FINDLAY CITY PLANNING COMMISSION

STAFF REPORT July 9, 2015

1. SITE PLAN APPLICATION #SP-18-2015 filed by Moody Development Ltd., 2215 Tiffin Avenue, Findlay for a proposed Zippy's Car Wash to be located at 2215 Tiffin Avenue.

TIFFIN AVENUE
(120' PUBLIC R/W)

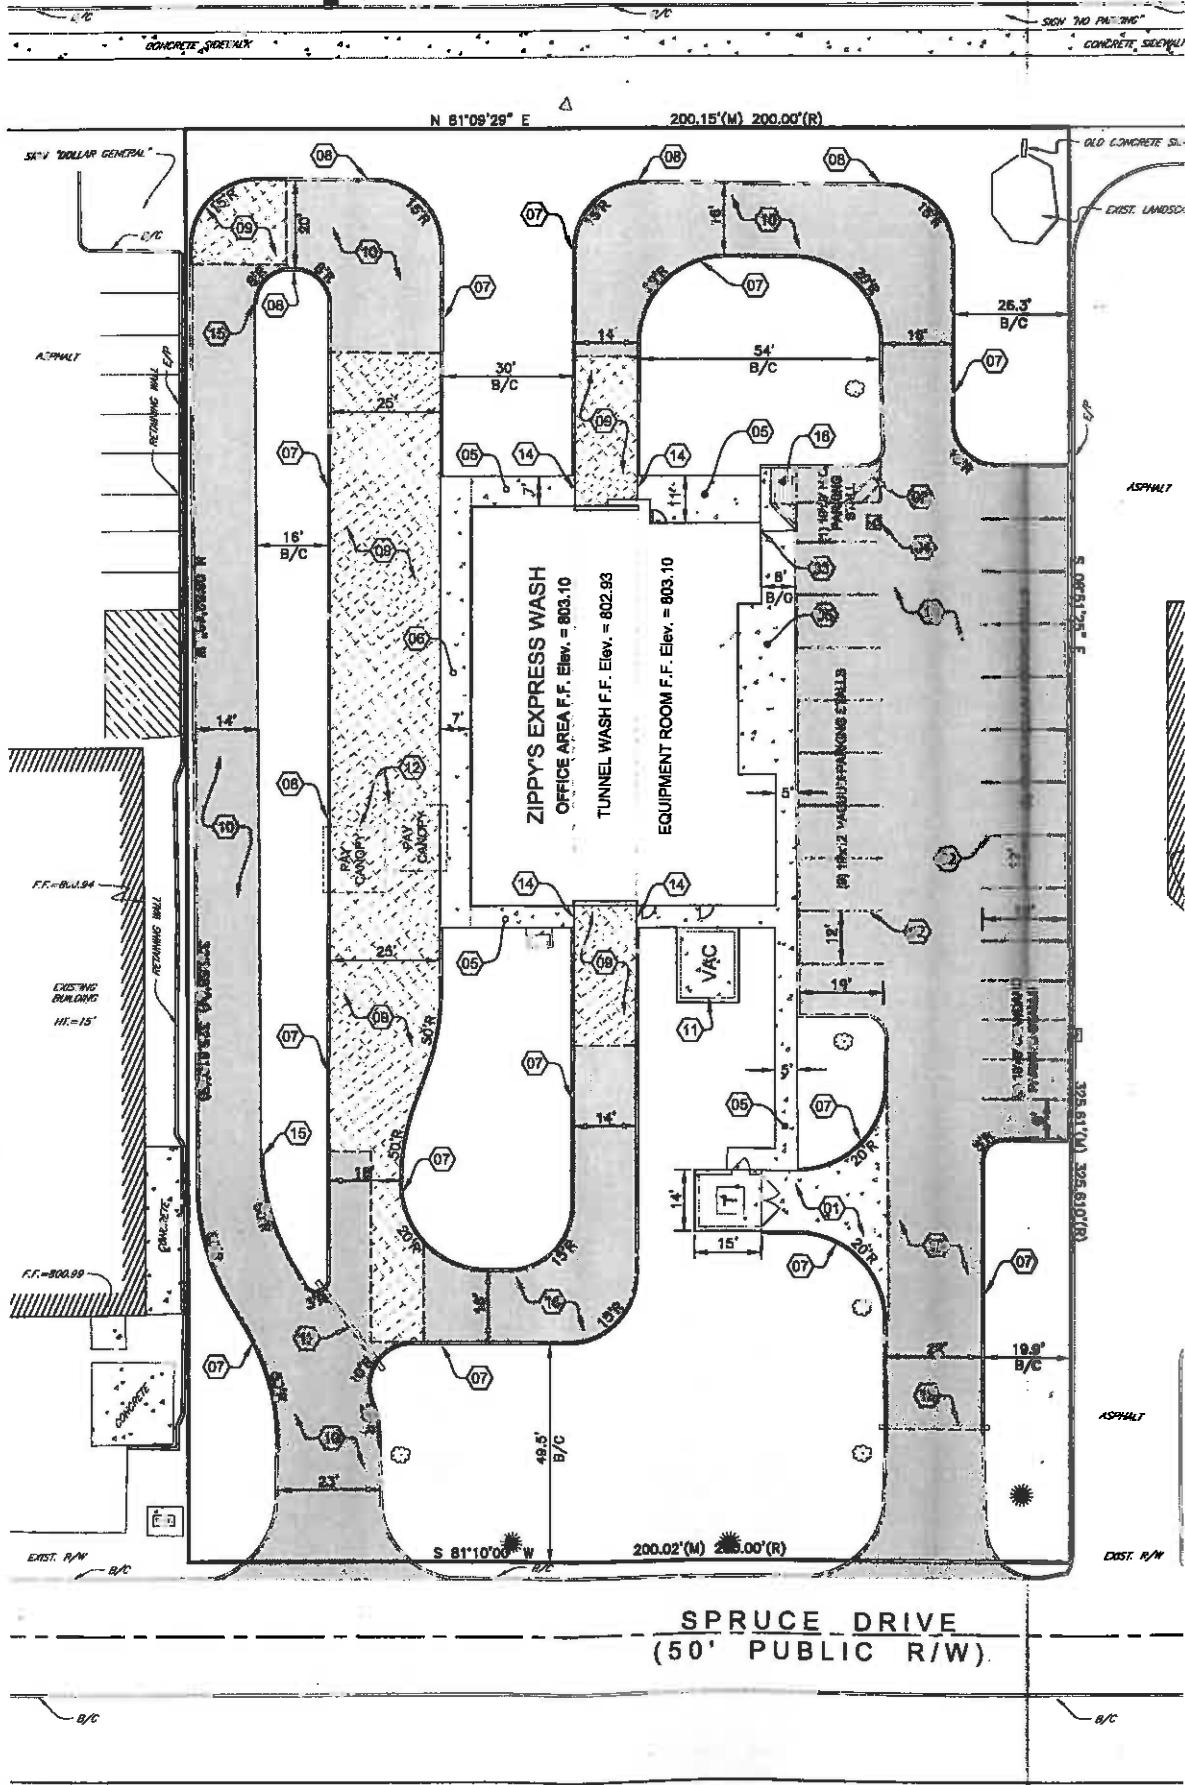
The applicant is proposing to demolish a portion of the west side of the existing former restaurant building and renovate into a car wash. The wash will be a single bay operation that is attended during hours of operation.

Access will be by means of the existing drives off of Spruce Drive. Vehicles will enter the site from the west drive, travel north and then south again to go through the pay canopy. Once they have paid they will follow the drive and go north again to enter the car wash. When they exit the north end, they will again head south where they can either stop to use the vacuums or continue southward to exit the site onto Spruce Drive.

There are 18 stalls on the east side of the building for vacuum use. The company submitted a noise study to Planning Commission in May for the vacuum areas. Levels were deemed as acceptable. There are also five regular plus one handicapped parking spots for employees or visitors. The applicant has stated that there will be only two employees on a shift most days with possibly three on the weekends.

A sign plan shows a monument type structure 6' in height and 8'-4" wide. The sign will be located in the northeast corner of the lot. It is shown 10' off the front lot line. The landscape plan indicates some new lawn areas, retention of some existing maples, crabapples and pine trees. More deciduous trees, pines and shrubs are being added to the perimeter of the site. Lilies and low shrubs are being added around areas of the foundation.

There is no new lighting proposed for the site. The developer will remove one light pole on the west side of the eastern drive and use the remaining existing light poles.

Another condition placed on the approval that day was that they would work with the City on the screening across Spruce Drive abutting the residential area. The City wants the developer to cover the cost of the buffer plan. The City will do the work and asks the developer to post a bond for the appropriate share based on their property width. The site plan indicates that the site is 200.02' wide.

Access – Access to the site will be provided by the two (2) existing curb cuts on Spruce Drive.

Water & Sanitary Sewer – The applicant is proposing to reuse the existing water service. The proposed sanitary service will be connected into the existing sanitary lateral. The Owner will be responsible for verifying the condition of the existing lateral. Since the use of the property is being changed, Engineering will need an estimate of the water usage to calculate any potential impact or capacity fees that could result from a higher water usage.

Stormwater Management – Detention for the site will be provided by the regional detention basin. The runoff from the site will be reduced since the proposed development will result in the addition of more green space on the site.

HRPC Staff recommends approval of **SITE PLAN APPLICATION #SP-18-2015 for a proposed Zippy's Car Wash to be located at 2215 Tiffin Avenue subject to the following conditions:**

- **Appropriate deed restrictions specifying that an auto wash on this site cannot run 24 hours**
- **Posting a bond to cover costs of buffer along Spruce Drive for the approximately 200' of property width as specified by the City**

Staff recommends approval of **SITE PLAN APPLICATION #SP-18-2015** for a proposed **Zippy's Car Wash** to be located at **2215 Tiffin Avenue** subject to the following conditions:

- **Appropriate deed restrictions specifying that an auto wash on this site cannot run 24 hours. (HRPC)**
- **Posting a bond to cover costs of buffer along Spruce Drive for the approximately 200' of property width as specified by the City (HRPC)**
- **Apply for all necessary permits with Wood County Building Department (FIRE)**
- **Any natural gas or electric meters within the driving area shall have crash protection. (FIRE)**

PROPOSED
ROAD SIGN

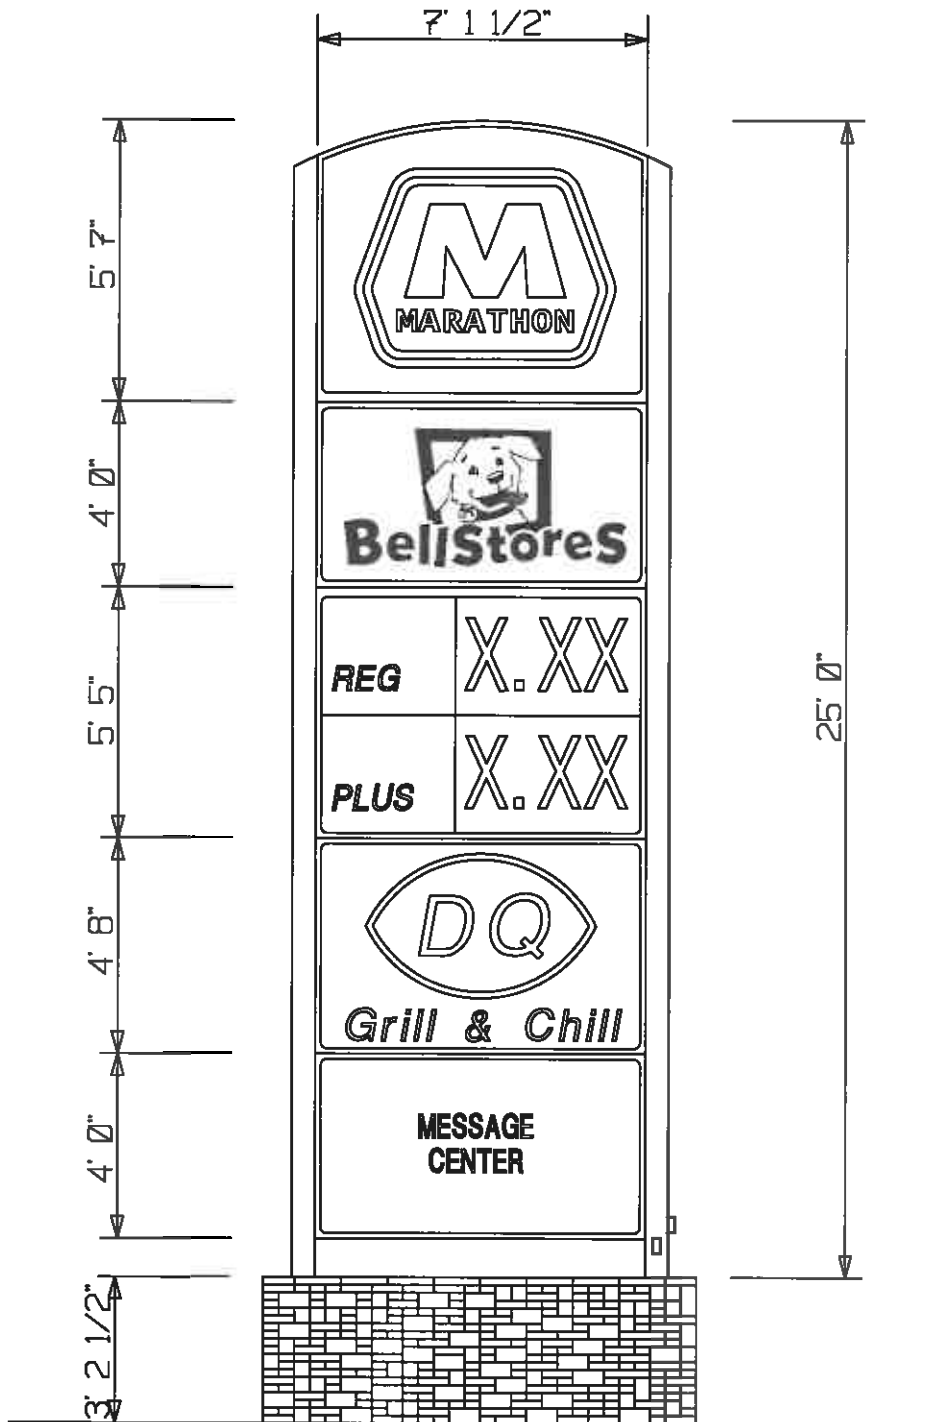
A sign detail shows a 28 ½' pylon sign along W. Main Cross Street. The majority of the sign is fixed message or just identification. An electronic message portion is indicated at the bottom. Electronic message centers can be no larger than 25% of the approved sign face. It looks like that portion is only a little over 28 square feet. The total sign is approximately 177 square feet. Todd Richard said that this site was given a variance on its sign and it would carry over with the land. Mr. Richard will address the sign issue. There is also an Interstate High Rise sign to the rear of the site along I-75. Mr. Richard said this is nonconforming and the applicant can only change out the panels unless they go for a variance.

- **Elimination of second curb cut from the west**
- **Granting of conditional use for a drive up window**
- **Confirmation of light pole height**
- **Obtain any signage approval or variances from the zoning department**

WASHINGTON ST. (60' R/W)

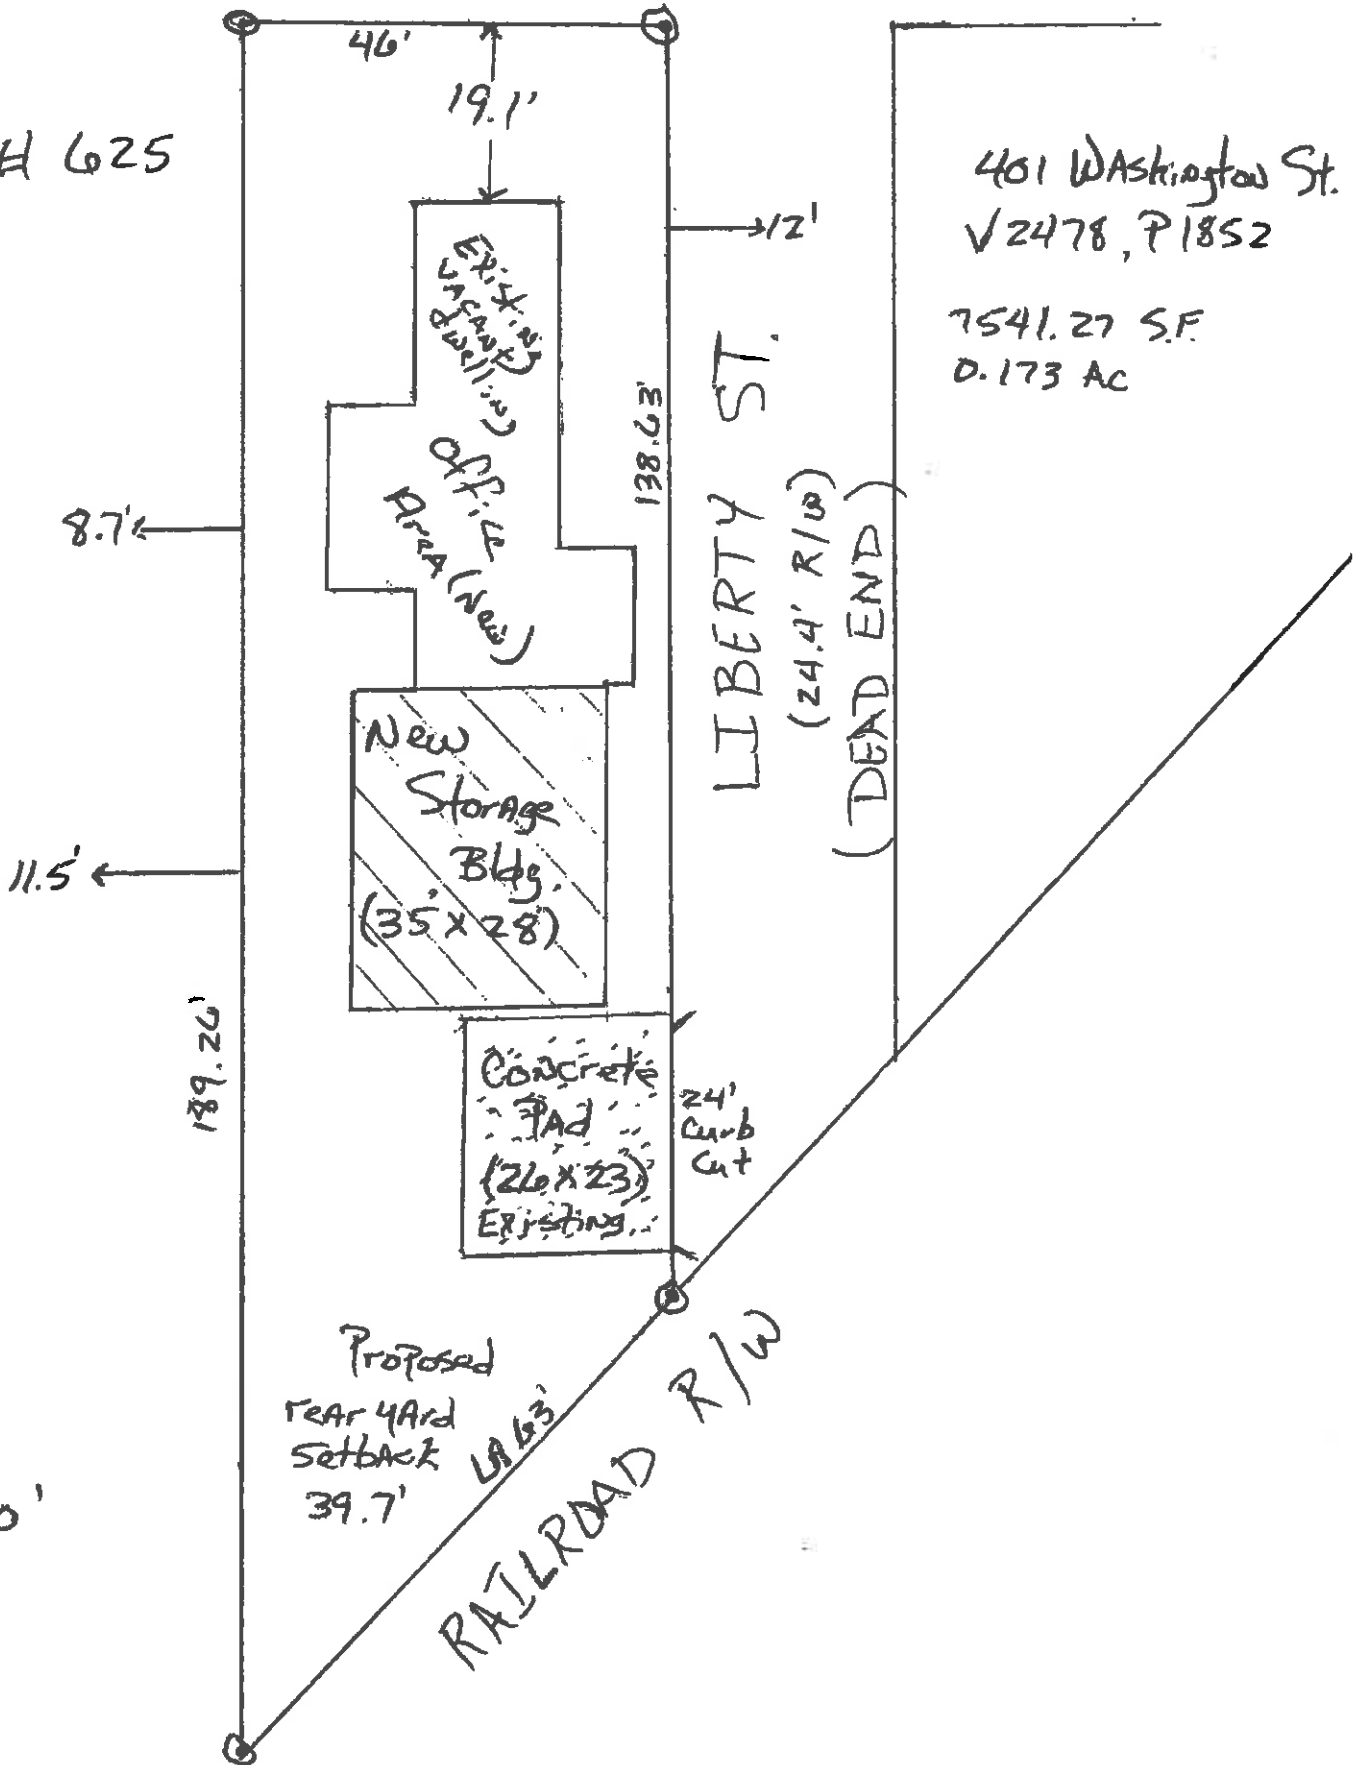
The applicant wishes to change the property to the location of his contracting business. He will remove a 13' x 15' back porch and attach a new garage to the back of the house. The intent is to use the front of the existing house as office. The garage will be accessed off of Liberty Street.

The applicant had originally proposed a much larger garage which would have required a variance on setbacks. He has since revised this to be a smaller structure that can meet the 30' rear yard setback. In the industrial zone an expansion of a building can continue along an existing building line so the usual side lot lines will not apply.

Our main concern with the project is that some type of screening be provided for the existing residential uses on either side of the parcel. Although they are also zoned industrial, they are legal nonconforming uses. We recommend a 6' privacy fence on the west and any part of the east side not necessary for access. The fence should be placed at the north end of the garage and extend to the rear of the lot.

We also have some concerns about whether there will be vehicles parked here. The applicant stated that his employees come in their own vehicles and load up and leave. Any vehicles left on site must be able to park on the existing concrete pad. If the street is vacated, it will become a private drive area and can be used as parking space also.

HRPC Staff recommends approval of **SITE PLAN APPLICATION #SP-20-2015 for proposed change of use and garage addition at 401 Washington Street, Findlay subject to the following conditions:**

- **6' privacy fence on east and west sides of garage**
